Docket Item # 2 & 3
BAR CASE # 2010-0326/329

BAR Meeting
December 15, 2010

ISSUE: Permit to Demolish/Encapsulate, Signage and Alterations (New Storefront)

LOCATION: 719 King Street

Figure 5. Proposed storefront alterations.

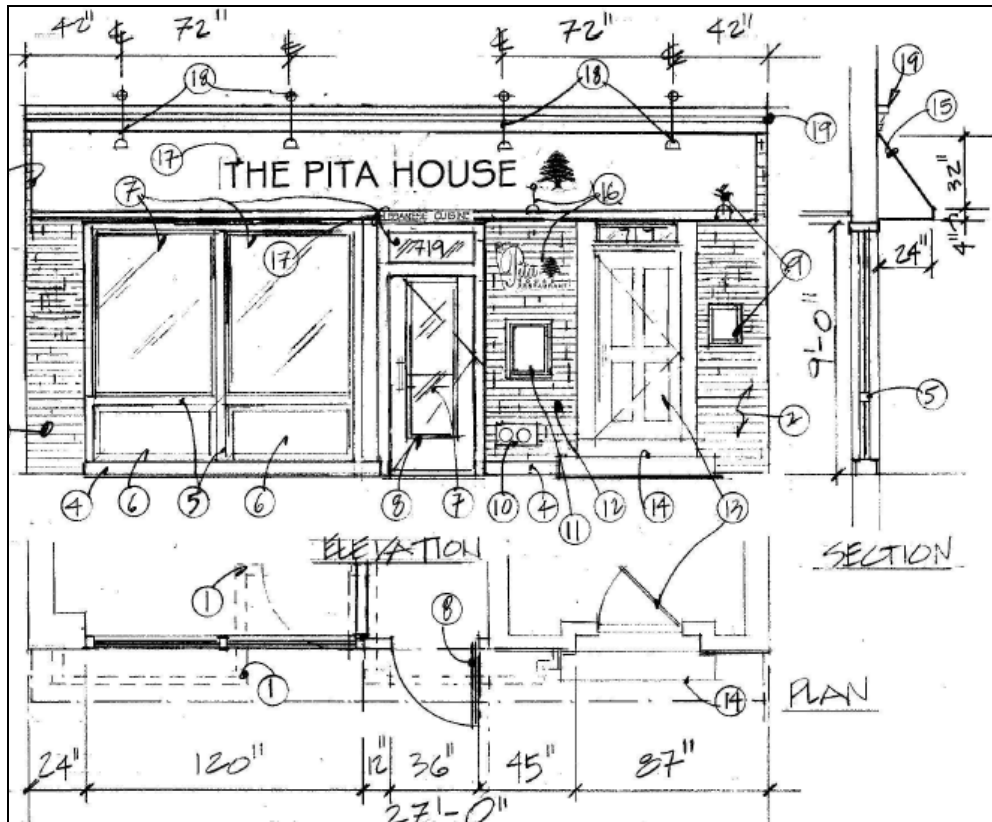
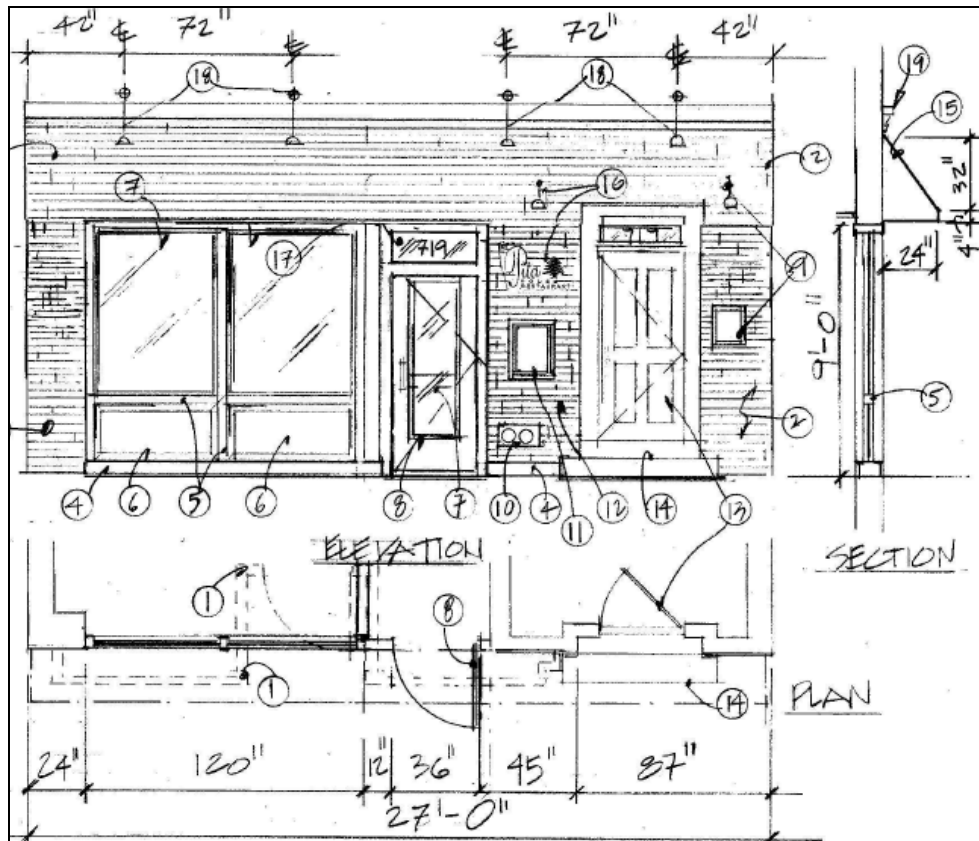
While the scope of the proposed changes to the storefront is significant at the street level, Staff is not concerned the integrity of the building will be compromised as a result of the proposed alterations. Although the retention of historic materials is a central tenet of historic preservation philosophy, Staff notes that the existing storefront has been so altered that little, if any, historic fabric will be lost with the installation of a new storefront. The proposed scheme retains all of the original portions of the front elevation, as well as the 1920s Beaux Arts style cornice. In addition, storefronts are a building feature typically altered over the life span of a building as they are modified to accommodate changing commercial needs. The proposed aluminum and glass storefront system, while distinctly modern, is appropriate as it allows one to “read” the evolution of the building over time and is similar to nearby storefronts. In addition, this type of storefront system can easily be reversed. The proposed design also uncovers portions of the historic brick wall at the first story and allows the weight of the brick structure to be visually transferred to the ground so that it is not floating above a glass storefront.

The proposal includes four gooseneck, wall wash light fixtures above the awning as well as smaller ones underneath the awning. While gooseneck lighting is architecturally appropriate above the awning, and is frequently approved by the Board, Staff recommends that a smaller, more discreet light fixture be used below the awning to illuminate the actual storefront, menu board, building directory and egress steps. The range of small, targeted light fixtures, whether as LED bars or targeted low voltage mini lights, has expanded significantly over the past few years. Staff recommends that a more subtle fixture be installed under the awning.

1. That the existing unused metal scroll bracket at the second story be removed from the building.
2. That the awning and signage be anchored through the mortar joints rather than into the brick.
3. That the applicant select a more discreet light fixture to illuminate the storefront and entrance under the awning, with final approval by Staff.
4. That the new metal door on the rear be painted oxide red to match the adjacent brick wall.

Figure 11. Existing rear (north) elevation from alley and proposed alterations.

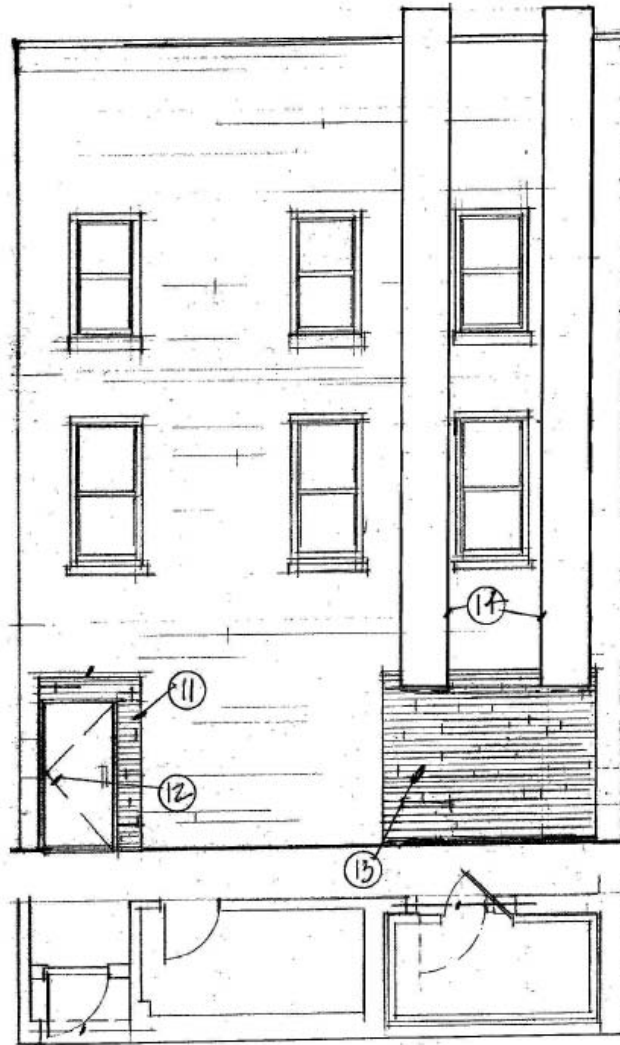
The use of a new flush metal door for the rear fire egress is consistent with the Board’s previous decisions on the rear of commercial buildings. Many commercial buildings on King and Washington streets have metal doors on the rear elevations. Although the *Design Guidelines* state that “exterior flush or paneled metal doors may be appropriate in certain limited circumstances for 20th century retail, commercial and industrial buildings,” Staff finds that this metal door, on what appears to be a late 20th century addition at the rear of this building, will be minimally visible and is architecturally appropriate for this utilitarian location. Staff, nevertheless, recommends that the door and frame be painted an oxide red color to match the adjacent brick wall..

- C-3 Identify size and material for lintel over new door opening in rear wall
- C-5 Canopies must comply with USBC 3202.3.1 for support and clearance from the sidewalk, and the applicable sections of USBC's Chapter 11. Structural designs of fabric covered canopies must comply with USBC 3105.3. The horizontal portions of the framework must not be less than 8 feet nor more than 12 feet above the sidewalk and the clearance between the covering or valance and the sidewalk must not be less than 7 feet.
